Work Order ID 159234

Item Name: Mounting Lug

DRAWING NO. D2731	TITLE MOUNTING LUG	REV. C	DART AEROSPACE USA, INC ENGINEERING ORDER		D.E.O. NO. D2731-C-1	SHEET NO. SHEET 1 OF 1	SCALE NTS
DRAWN DATE 11.05.02	CHECKED DATE 11.05.09	SC	MFG. APPR. <i>[Signature]</i>	APPROVED DATE 11.05.09	DE APPR. <i>[Signature]</i>	DATE 11.05.09

ADD D2731-xRG OPTION

D2731-1 MOUNTING LUG

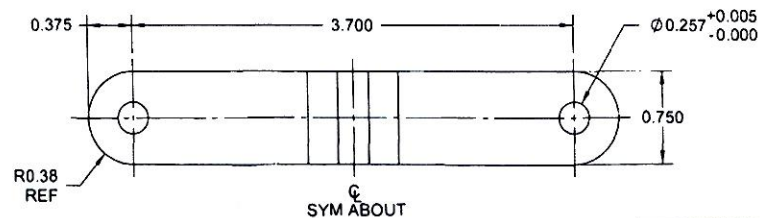
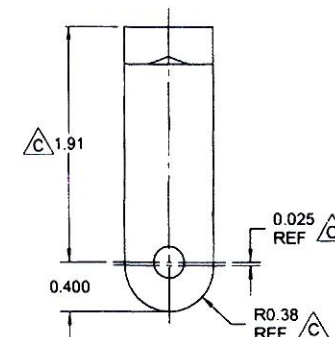
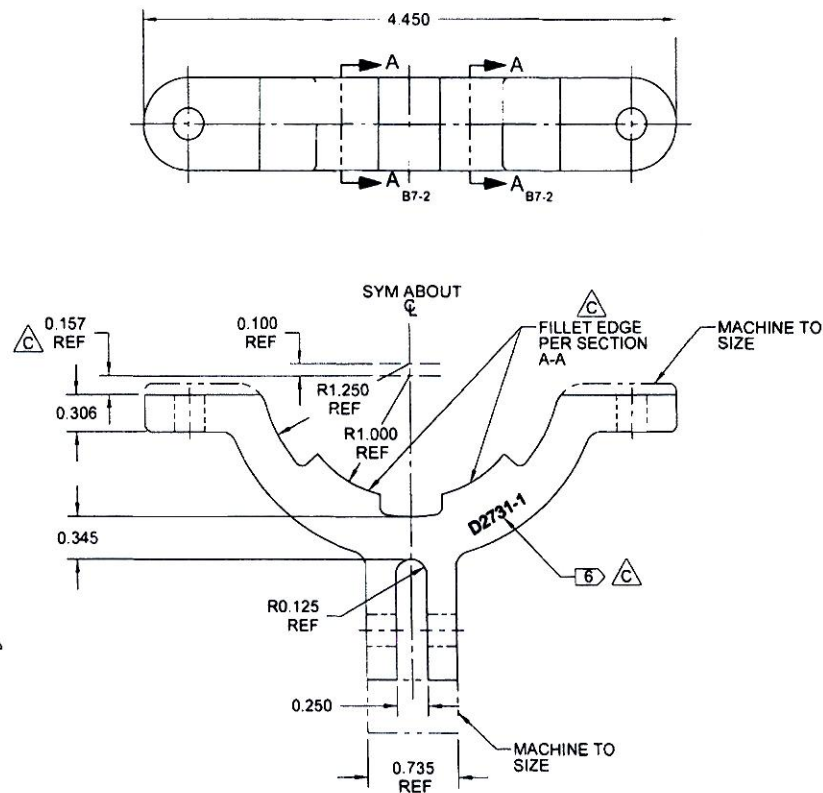
C	REDRAWN IN SOLIDWORKS TO CURRENT DESIGN STANDARDS. REFER TO SECTION A-A, B-B, C-C & D-D. FILLET ADDED TO PREVENT CHAFING OF RUBBER CUSHION ON INSTALLATION.	AJS	09.01.19
B	REVISED DIMENSIONS	KE	99.07.06
A	NEW ISSUE	KE	98.05.13
REV	DESCRIPTION	BY	DATE
DESIGN	KE	DART AEROSPACE USA, INC. PORT HADLOCK, WA	
DRAWN	AJS		
CHECKED		DRAWING NO.	REV. C
MFG. APPR.		D2731	SHEET 1 OF 5
APPROVED		TITLE	SCALE
DE APPR.		MOUNTING LUG	NTS
DATE	09.01.19	COPYRIGHT © 1998 BY DART AEROSPACE USA, INC. THIS DOCUMENT IS PRIVATE AND CONFIDENTIAL AND IS SUPPLIED ON THE EXPRESS CONDITION THAT IT IS NOT TO BE USED FOR ANY PURPOSE OR COPIED OR COMMUNICATED TO ANY OTHER PERSON WITHOUT WRITTEN PERMISSION FROM DART AEROSPACE USA, INC.

D2731-1RG MOUNTING LUG (SHOWN)
D2731-3RG/-5RG/-7RG MOUNTING LUGS (SIMILAR)

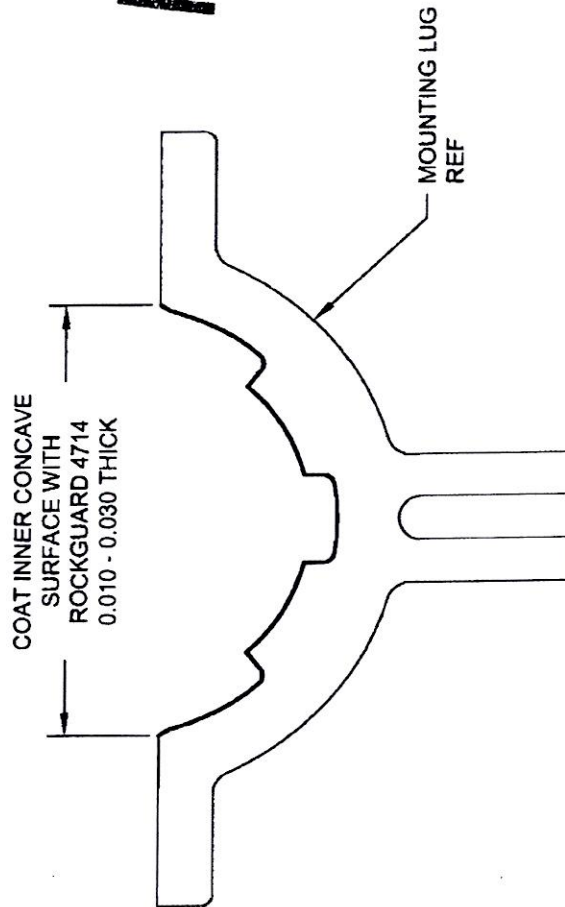
D2731-xRG MOUNTING LUGS ARE IDENTICAL TO D2731-x MOUNTING LUGS, HOWEVER AFTER FINISH, COAT INNER CONCAVE SURFACE WITH "PLUS ONE ROCKGUARD 4714" AS SHOWN BELOW.
